APPLICATION NO.	FILING DATE	FIRST NAMED INVENTOR	ATTORNEY DOCKET NO.	CONFIRMATION NO.
10/542,259	12/30/2005	Horst Wisniewski	H0075.70107US00	5101
	7590 09/24/200 IFIELD & SACKS, P.(EXAMINER		
600 ATLANTIC AVENUE			NGUYEN, PHONG H	
BOSTON, MA 02210-2206			ART UNIT	PAPER NUMBER
			3724	
			MAIL DATE	DELIVERY MODE
			09/24/2009	PAPER

DETAILED ACTION

Claim Rejections - 35 USC § 103

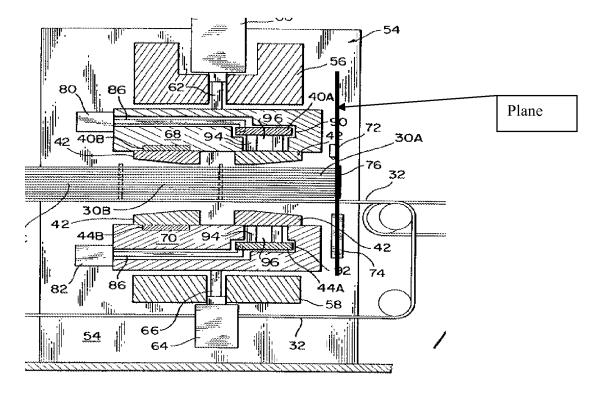
The Applicant argues that the left surface of element 76 is not the plane of the workpiece. This argument is not persuasive. The right surface of workpiece 30A abuts the left surface of the element 76. Therefore, the Examiner considers the left surface of element 76 as the claimed plane.

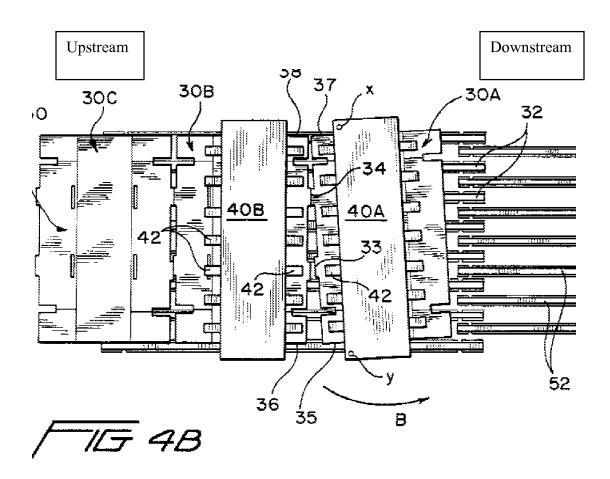
The Applicant argues the jaws (right members 42) do not move up and down. This argument is not persuasive. The term "up and down" is a broad term. It has two meanings: up and down in vertical direction, and up(stream) and down(stream) of a conveyor assembly. The Examiner interprets it as up(stream) and down(stream) of a conveyor assembly. As shown in Fig. 4B below, the moveable pair of jaws (right members 42) moves upstream and downstream (in B direction) with respect to a plane of the workpiece.
